INDESIT company

Model type:
TA5VFR

Commercial code:
F040722

RE0242T0 Exploded views

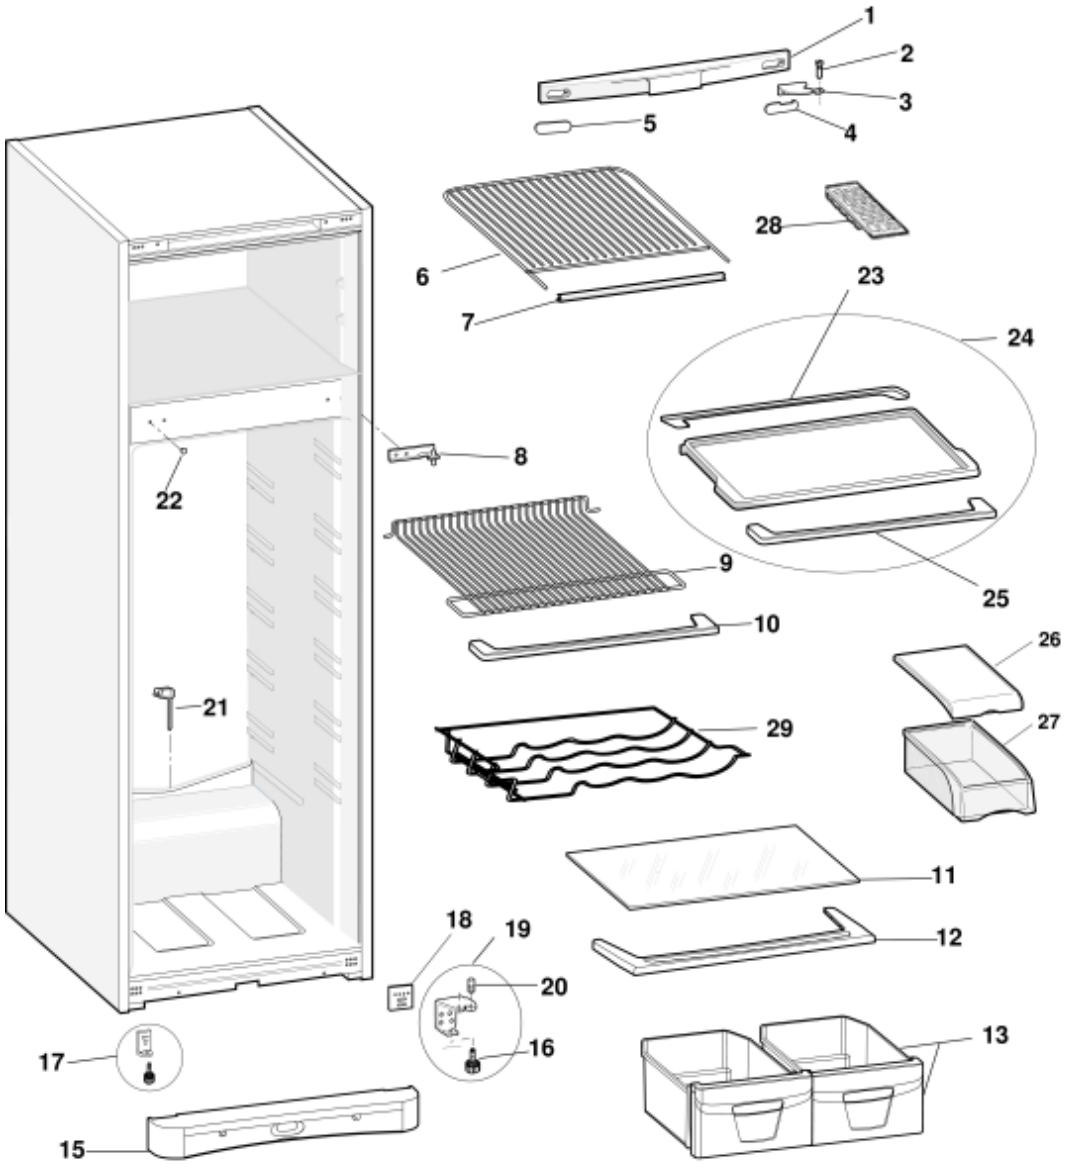
n2511i00: ACCESSORIES' COLOR CHANGE

Light blue/light green accessories has been replaced with those in transparent version. At the end of stock only transparent spare parts will be managed.

RE0243T0 Exploded views

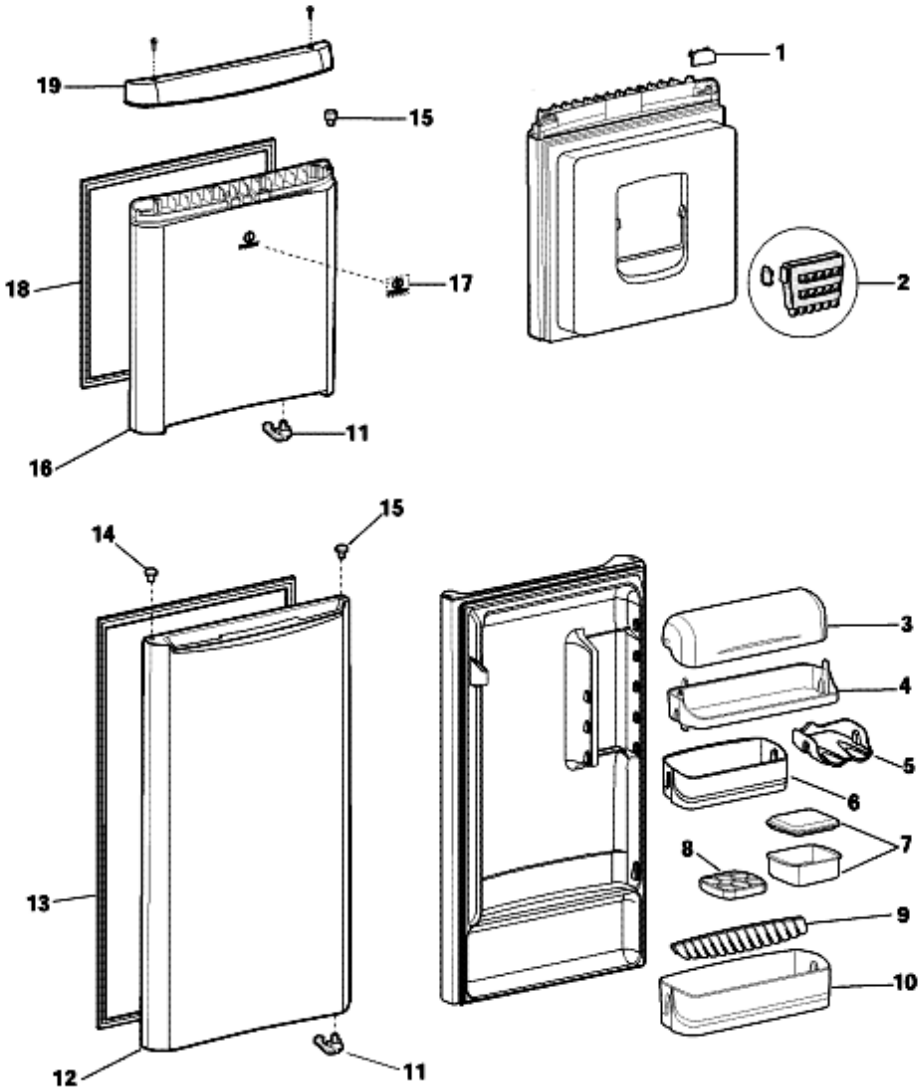
n2511k01: ICE TRAY STANDARDIZATION

Ice tray has been standardized in order to manage only 12cubes version.

n2510e00: ELIMINATION OF ICE BOX INTEGRATED ON DOOR

From S/N 00218... on DD L70 models has been deleted ice box integrated in inner door and it has been substituted with door without integrated ice box plus added of "normal" ice box. At the end of stock will be managed only doors without integrated ice box.

SUBSTITUTED CODES ARE:

C00117948
C00098205
C00117771
C00110211

NEW CODES ARE:

C00196559
C00117027
C00252517
